Product/Process Change Notice

PCN No.: P-1712-0021

Subject: 75nm Serial NOR Flash to be manufactured at Fab 2 (8" fab) since Jan., 2018

Change Category: Additional Manufacturing Site

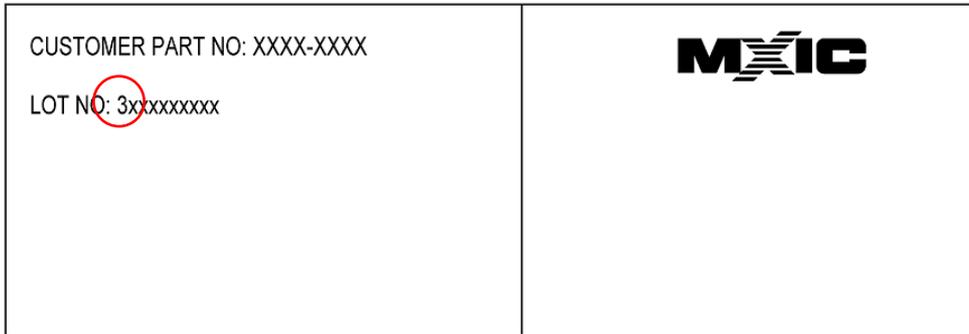
2). Package top marking can also identify the wafer Fabs, lot# starts with number "2, 3, or 5" means the device is from Fab 2, whereas Lot# starts with number "7,8, or 9" means the device is from Fab 5 (see below marking illustration as an example, lot# starts with a "3" means it is from Fab 2)
